UNITED STATES PATENT AND TRADEMARK OFFICE

10/528,215

Bernd Salomon-Bahls

Office Action Summary	Application No. 10/528,215	Applicant(s) SALOMON-BAHLS, BERND	
	Examiner Fannie Kee	Art Unit 3679

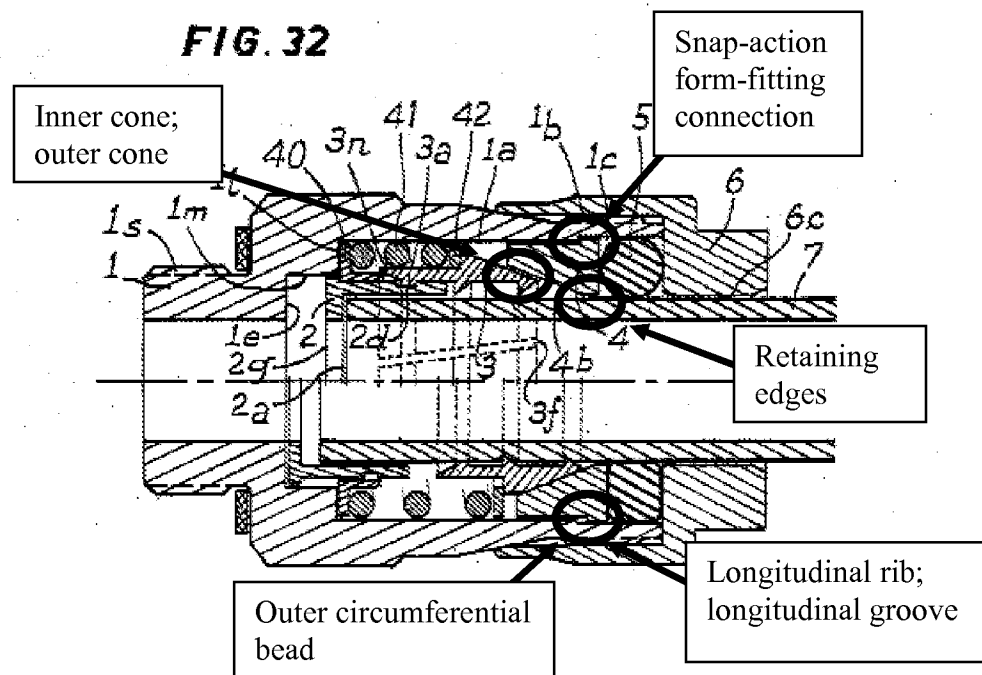
With regard to claim 21, and as seen in Figure 32 below, Legris discloses a connecting device for a plug-in connection for at least one pipeline, the plug-in connection comprising a housing part (1, 4) having at least one receiving opening (1a) for the insertion of the pipeline, a

clamping ring (3) arranged in the receiving opening and, in order to lock the pipeline in place within the receiving opening, an outer cone surface of the clamping ring interacts with an inner cone surface of the housing part, the housing part being made in two parts from a base part (1) and an insert part (4) which is connected to the base part via a snap-action form-fitting connection which includes the inner cone surface, and the insert part having a dirt seal (5) for resting on the circumference of the pipeline in place within the receiving opening.

With regard to claim 32, and as seen in Figure 32 above, Legris in view of Wallace et al disclose the insert part having positioning means on its outer circumference for the automatic aligning on insertion into the base part, the positioning means being at least one radially projecting longitudinal rib which runs axially in the insertion direction and engage in a corresponding longitudinal groove of the base part.

With regard to claim 33, and as seen in Figure 32 above, Legris in view of Wallace et al disclose retaining edges within the insert part following the inner cone as an axial end stop for the clamping ring.

With regard to claim 35, and as seen in Figure 32 above, Legris discloses a connecting device for a plug-in connection for at least one pipeline, the plug-in connection comprising a housing part (1, 4) having at least one receiving opening (1a) for the insertion of the pipeline, a clamping ring (3) arranged in the receiving opening and, in order to lock the pipeline in place within the receiving opening, an outer cone surface of the clamping ring interacts with an inner cone surface of the housing part, the housing part being made in two parts from a base part (1) and an insert part (4) which is connected to the base part via a snap-action form-fitting connection which includes the inner cone surface, and the insert part having a dirt seal (5) for resting on the circumference of the pipeline in place within the receiving opening; and

With regard to claim 36, and as seen in Figure 32 above, Legris in view of Wallace et al disclose that the insert part (4), for the circumferential sealing toward the base part, can be inserted into the base part with a press fit and has an outer circumferential sealing bead.

With regard to claim 37, and as seen in Figure 32 above, Legris in view of Wallace et al disclose the circumferential sealing bead of the insert part being attached to the insert part with a material to form a single piece but does not disclose that the circumferential sealing bead consists of an elastic material.

With regard to claim 40, and as seen in Figure 32 above, Legris discloses a connecting device for a plug-in connection for at least one pipeline, the plug-in connection comprising a housing part (1, 4) having at least one receiving opening (1a) for the insertion of the pipeline, a clamping ring (3) arranged in the receiving opening and, in order to lock the pipeline in place within the receiving opening, an outer cone surface of the clamping ring interacts with an inner cone surface of the housing part, the housing part being made in two parts from a base part (1) and an insert part (4) which is connected to the base part via a snap-action form-fitting

Examiner disagrees. See Figure 32 above for the snap-action form-fitting connection. What is Applicant defining as a snap-fit connection? Applicant claims a snap-action form-fitting connection between the base part and the insert part and not a "snap-fit connection". The base part and insert part of Legris are form-fitting together and have a "snap-action" when assembled.
